**Wisconsin
Electric**
POWER COMPANY

VPNPD-90-300
NRC-90-059

DOCKETS 50-266 AND 50-301
SUBMITTAL OF QUALITY ASSURANCE PROGRAM DESCRIPTION CHANGES
POINT BEACH NUCLEAR PLANT - UNITS 1 AND 2

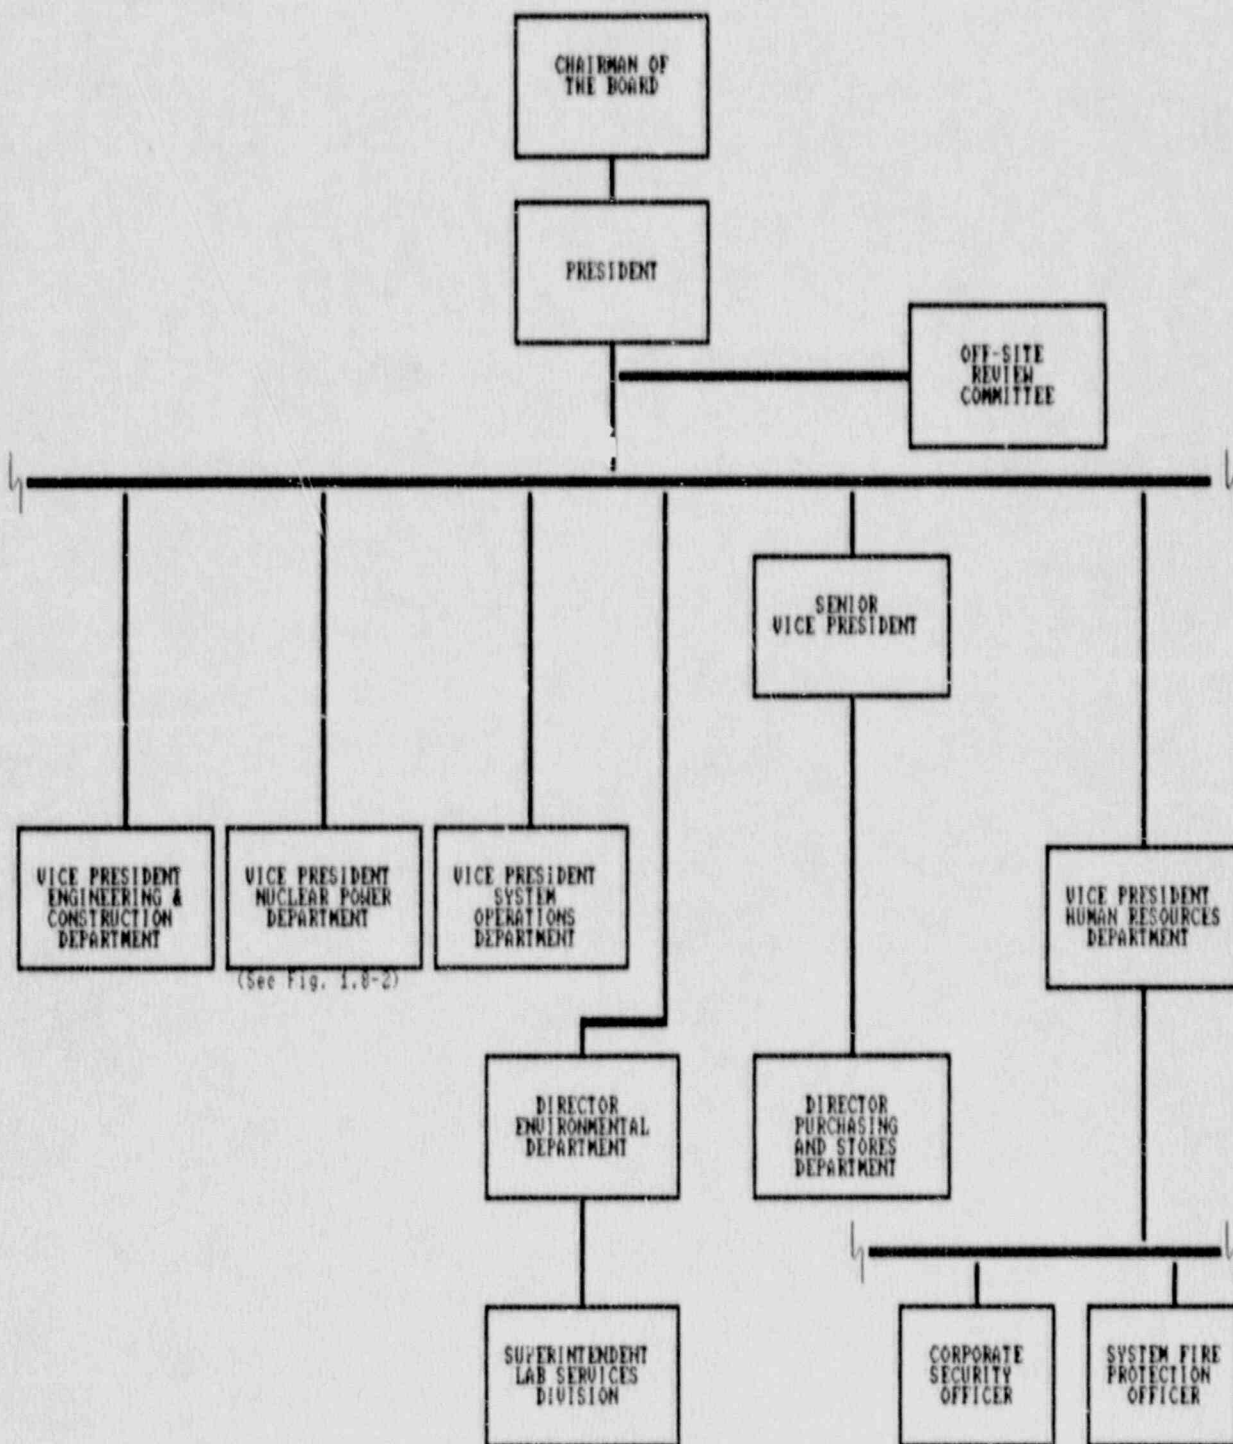
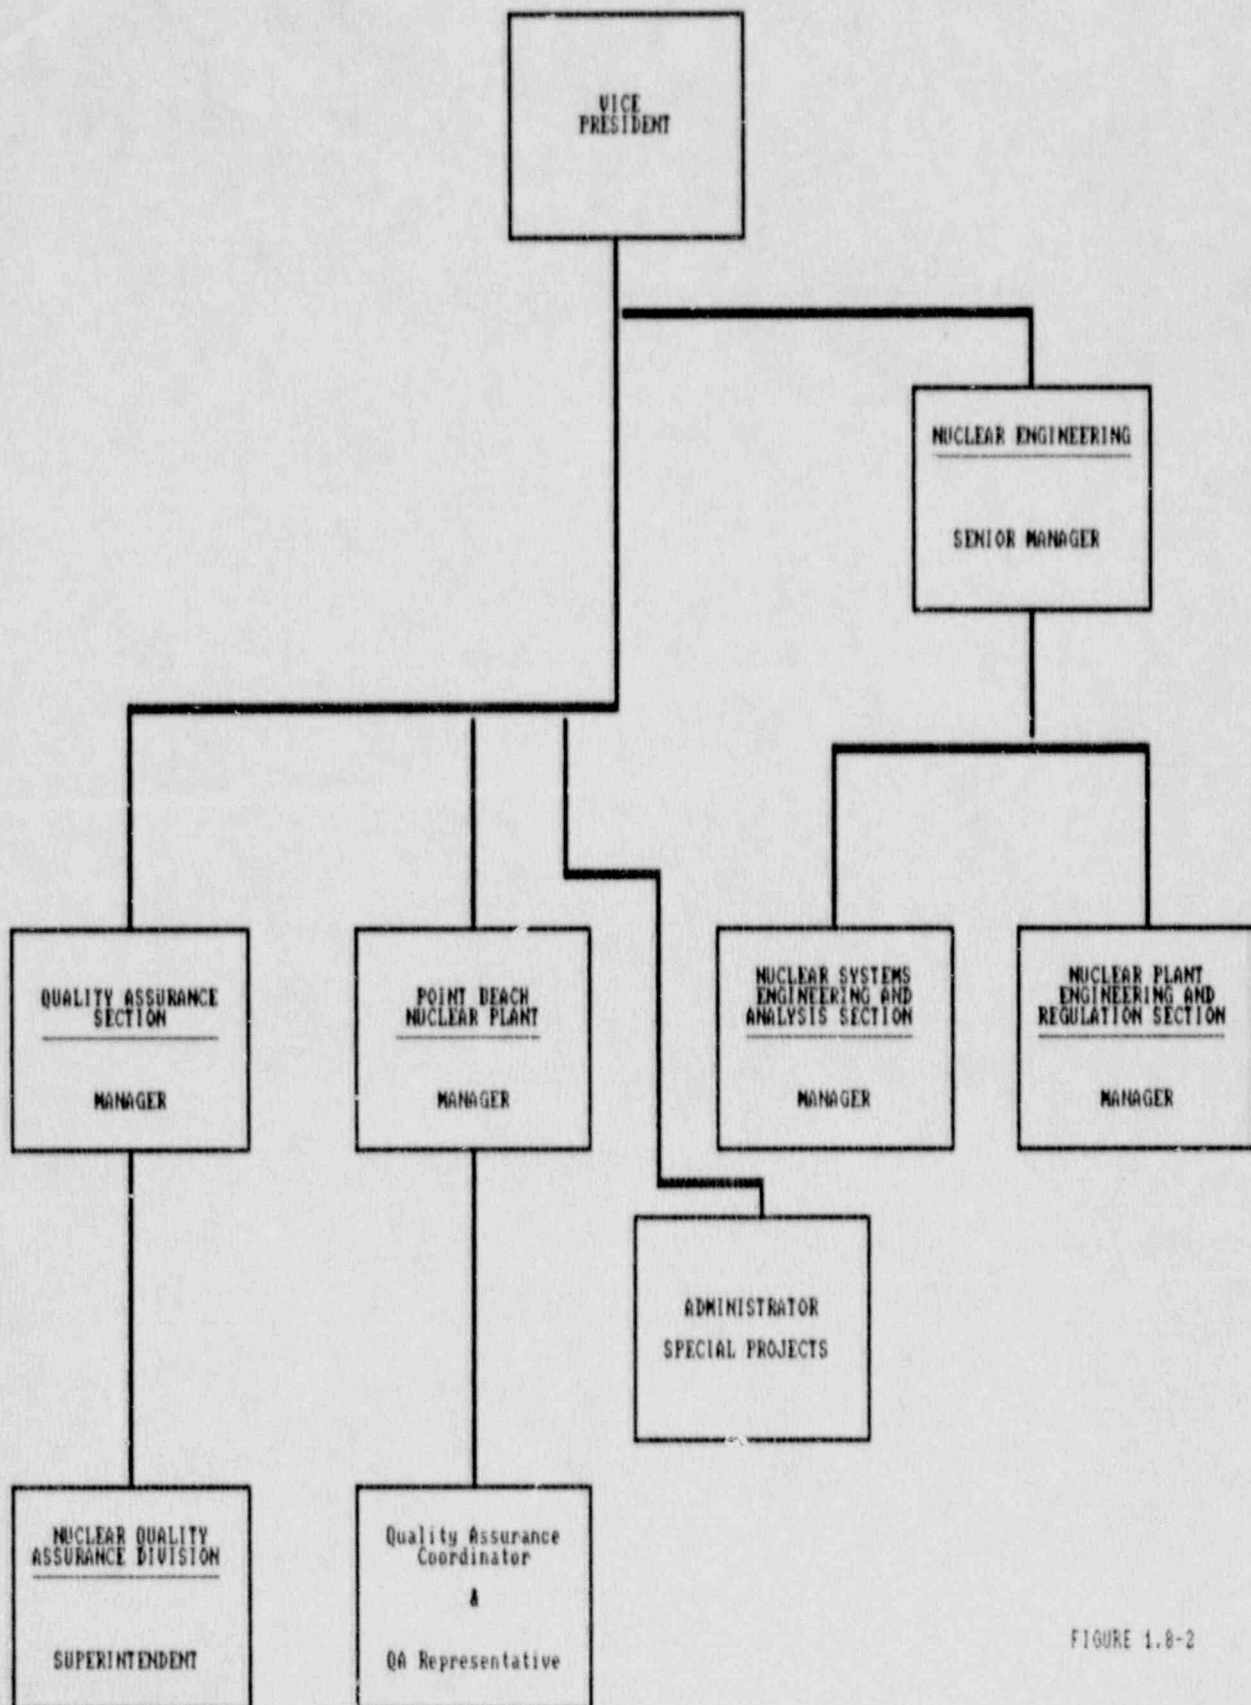
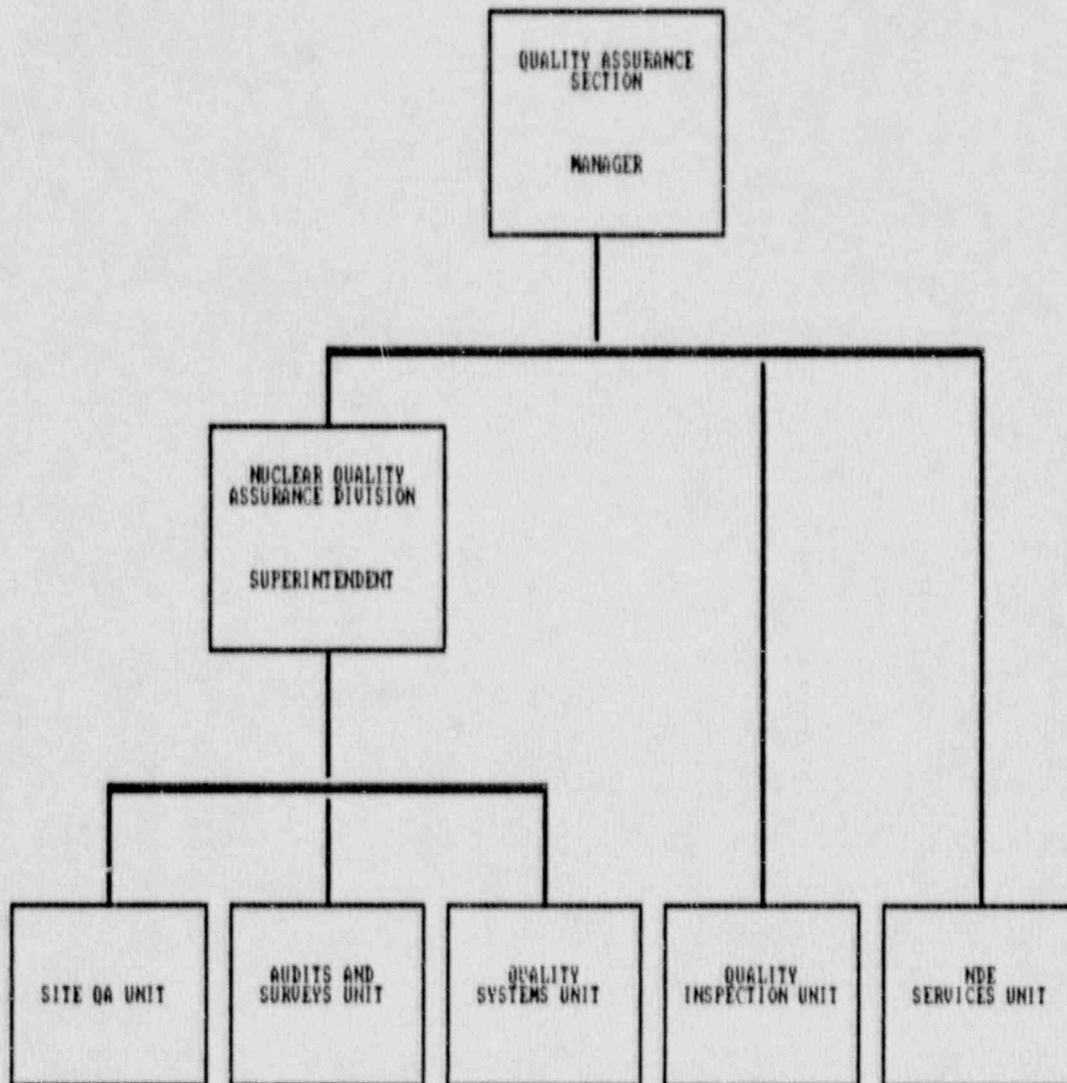
- A. Page 1.8-4, Paragraph 3 - The reporting level for the Vice-President Nuclear Power is changed to the President.
- B. Page 1.8-5, Paragraph 2 - "QA Volume I" changed to "PBNP Administrative Control Policies and Procedures Manual" to more accurately describe the document.
- C. Page 1.8-5, Paragraph 3 - Changed General Superintendent to Manager.
- D. Page 1.8-8, Paragraphs 1 and 2 - Changed General Superintendent to Manager.
- E. Page 1.8-8, Paragraph 4 - Changed Chairman to President for both occurrences.
- F. Figures 1.8-1, 1.8-2, and 1.8-3 - The figures are revised to reflect the changes noted above.
